Part Analysis

WL2020.3.6

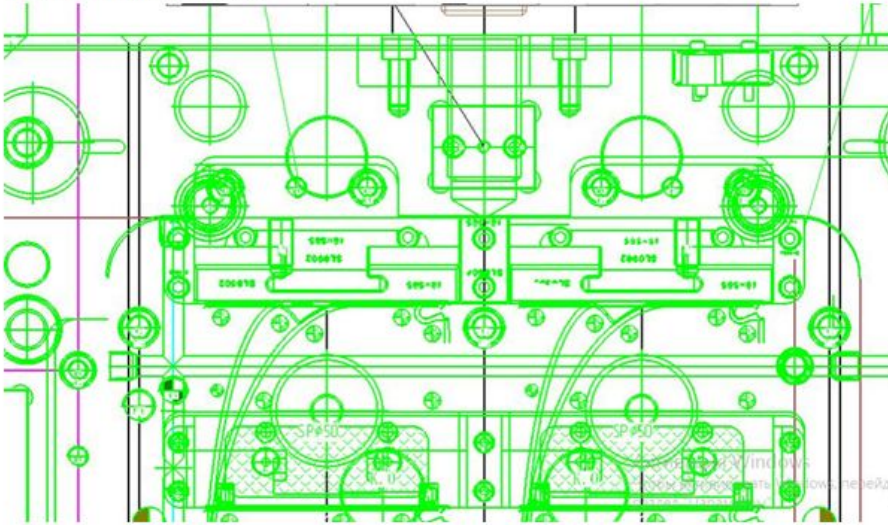
1) Please make 2 sliders? Not one: 请做 2 个行位，而不是一个

Now:现在

Please use this idea: 请用这个

we can have cooling with only one slider, there was not cooling with two slider, we suggest to keep our design.

the same problem as DIV 120 285-485(WL200-80).

原来做两件的行位是没有运水的, 现在我们把做成一件是为了上运水

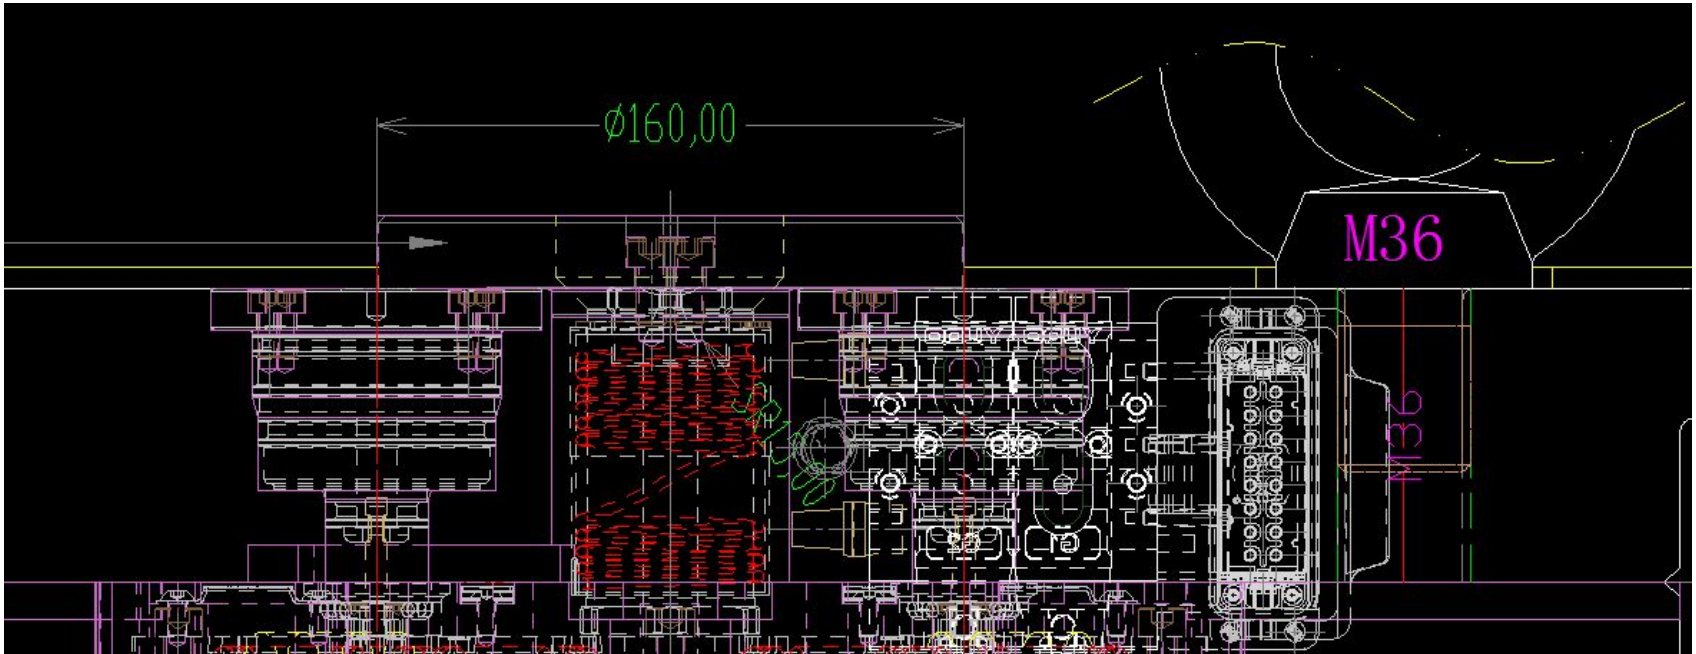
2) Please make flange diameter 160mm. 定位环直径 160mm

it is 160mm in our drawing, we didn't mark the dimension.
the same problem as DIV 120 285-485(WL200-80).

发过去的图纸定位环是160mm的。
是我们没有表数。

WL200-80的图纸一样的问题
